Contract #: 04-0120F4Cty: SF/ALA Rte: 80 PM: 13.2/13.9File #: 69.25B**QUALITY ASSURANCE -- NON-CONFORMANCE REPORT****Location:** Changxing Island, Shanghai, P.R. China**Report No:** NCR-000653**Prime Contractor:** American Bridge/Fluor Enterprises, a JV**Date:** 25-Jan-2010**Submitting Contractor:** Zhenhua Port Machinery Company, Ltd (ZPMC), Changxing Island**NCR #:** ZPMC-0624**Type of problem:**

To:	AMERICAN BRIDGE/FLUOR, A JV 375 BURMA ROAD OAKLAND CA 95607	Date:	26-Jan-2010
Dear:	Mr. Charles Kanapicki	Contract No:	04-0120F4 04-SF-80-13.2 / 13.9
Attention:	Mr. Thomas Nilsson Project/Fabrication Manager	Job Name:	SAS Superstructure
Subject:	NCR No. ZPMC-0624	Document No:	05.03.06-000612

NCR PROPOSED RESOLUTION

Job Name: SAS Superstructure

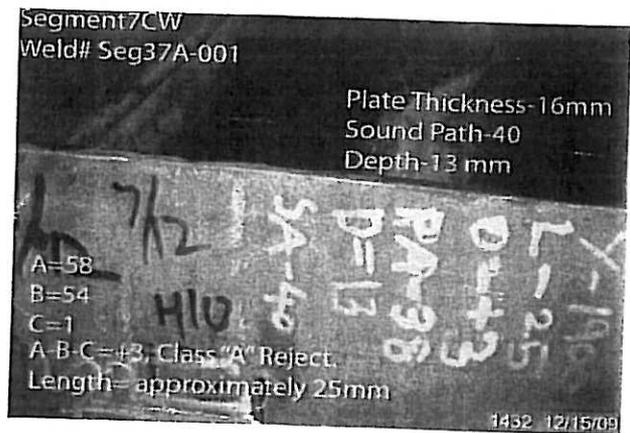
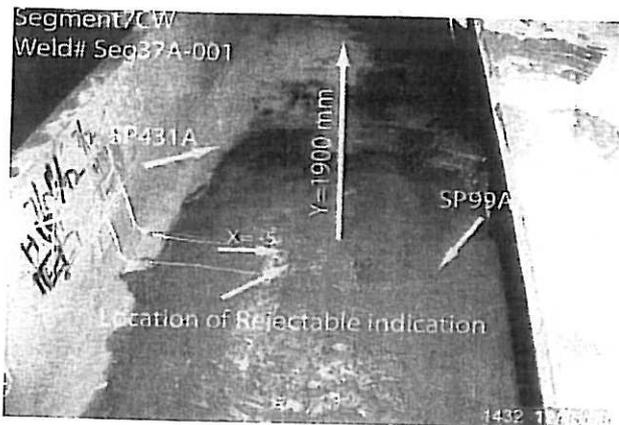
During the Quality Assurance Ultrasonic Testing (UT) review of weld located on OBG Segment 7CW, this Quality Assurance Inspector (QA) discovered the following issue:

- A total of one (1) rejectable Class "A" indication measuring approximately 25mm in length.
 - The Weld is a complete joint penetration (CJP) Butt Weld joining Side Plate SP99A to SP431A and is identified as SEG37A-001.
 - The Segment is located in the repair yard north of the blast shop.
- The Notice of Witness Inspection Number (NWIT) is 004866. The indication is located inside the area that has been previously tested and accepted by ZPMC Quality Control (QC) personnel. As per the contract documents, ZPMC's QC personnel are required to perform 100% (UT) inspection of this splice weld.

项目名称 Project Name	美国海湾大桥 SFOBB	部件图号 Drawing No	SEG037A	报告编号 Report No.	B-WR12122
合同号 Contract No.	04-0120F4	部件名称 Items Name	7CW BOTTOM AND SIDE PLATE LATE SPLICE	NDT报告编号 Report No. of NDT	B787-UT-12336
项目编号 Project No.:	ZP06-787

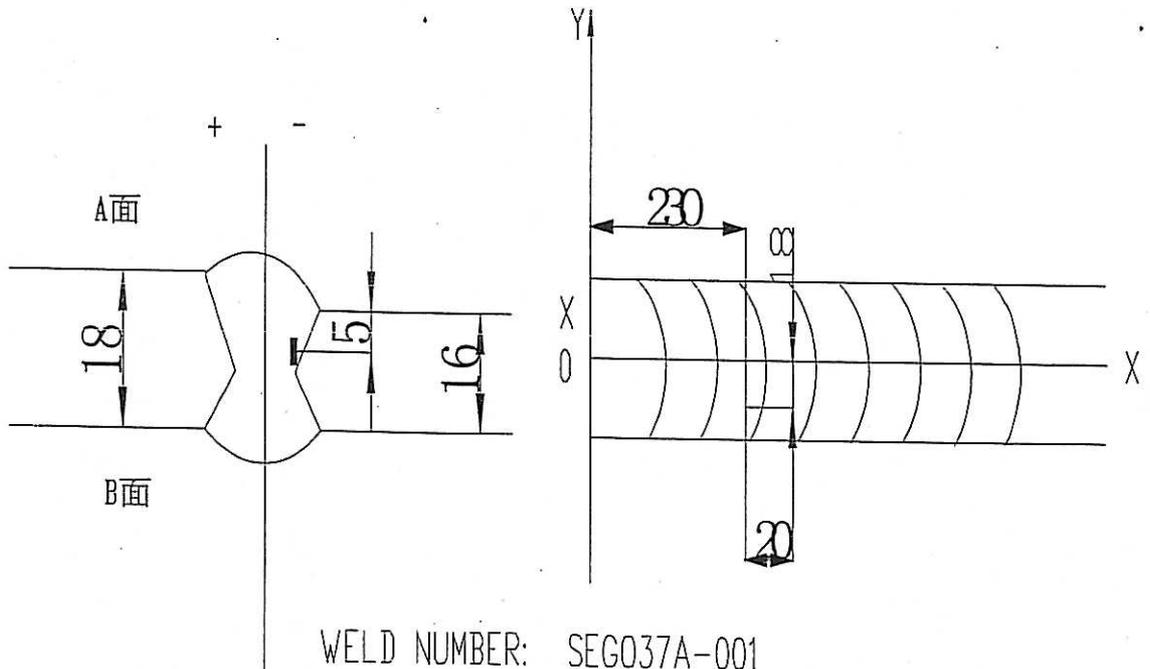
Rejected indication found by ultrasonic inspection is less than the maximum allowance aggregate length.

(UT探伤发现的缺陷总长度小于最大允许长度。) SEG037A-001

1. Did not clear the weld pass completely in time.

1. Gouge or grind from nearer side from metal edge ($D \leq 0.65T$, " D " is depth of defects, " T " is thickness of metal) to remove all defects;

2. Follow repair WPS for joint preparation, preheat, and weld deposit;

3. Verify with VT no defects remain in the weld joint prior to welding;

4. Grind the repaired area flush with base metal or the adjacent weld;

5. Perform UT inspection to the weld along with 50mm on each end of the repair area;

WELD NUMBER: SEG041C-013

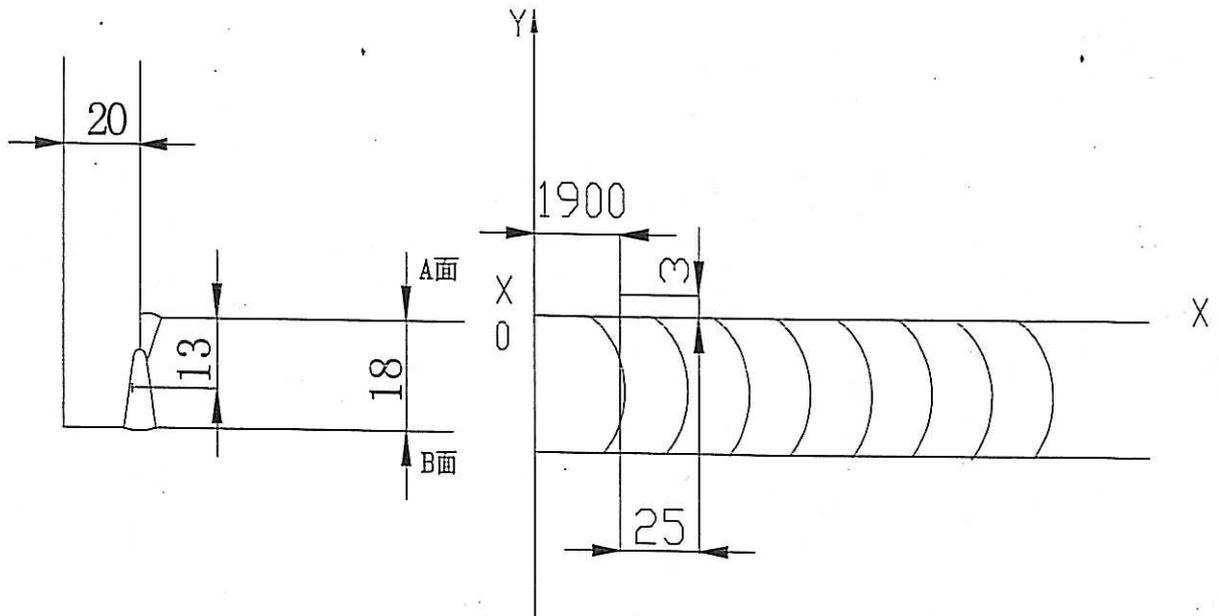
Rejected indication found by ultrasonic inspection is less than the maximum allowance aggregate length.

(UT探伤发现的缺陷总长度小于最大允许长度。) SEG041C-013

1. Did not clear the weld pass completely in time.

1. Gouge or grind from nearer side from metal edge ($D \leq 0.65T$, "D" is depth of defects, "T" is thickness of metal) to remove all defects;

2. Follow repair WPS for joint preparation, preheat, and weld deposit;

3. Verify with VT no defects remain in the weld joint prior to welding;

4. Grind the repaired area flush with base metal or the adjacent weld;

5. Perform UT inspection to the weld along with 50mm on each end of the repair area;

Procedural Procedural **Description:** Missed MT indication by QC

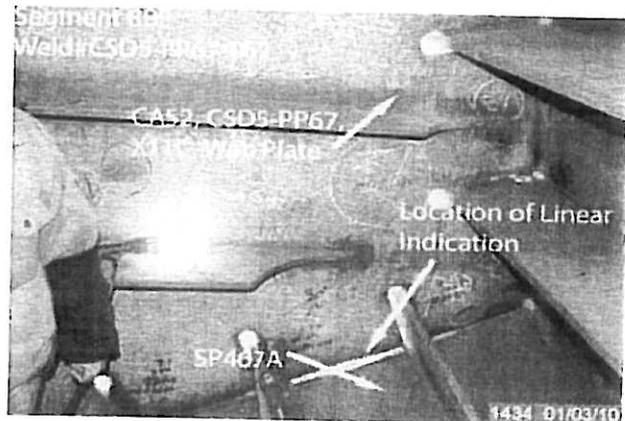
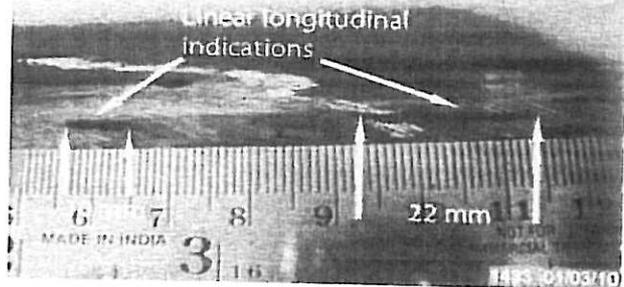
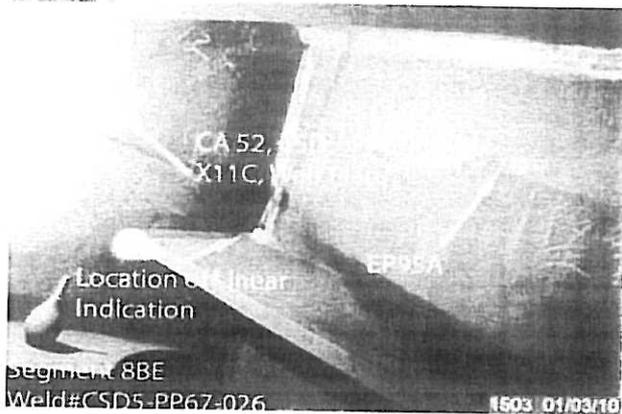
Reference Description: MT indications discovered after ZPMC had tested and accepted welds on Segment 8BE Corner Assembly

The Notice of Witness Inspection Number (NWIT) is 004978. The indication is located inside the area that has been previously tested and accepted by ZPMC Quality Control (QC) personnel. ZPMC's QC personnel are required to perform twenty five (25%) percent MT inspection of this weld.

-The weld is identified as CA051-010 at panel point (PP64.5 in Segment 8BE).

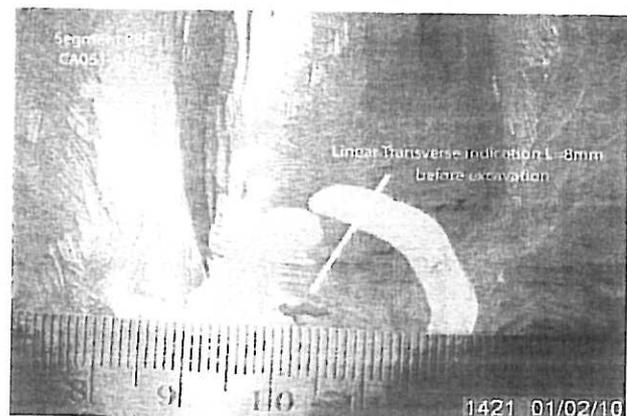
During the Quality Assurance Magnetic Particle Testing (MT) review of welds located on OBG Corner Assembly, this Quality Assurance Inspector (QA) discovered the following issue:

-One (1) Transverse linear indication that measured approximately 8mm in length.

-The weld is a fillet weld joining the Vertical Longitudinal Truss (X74H) to the Side Plate (SP458A)

Repair said indication and perform NDT required to verify weld quality.
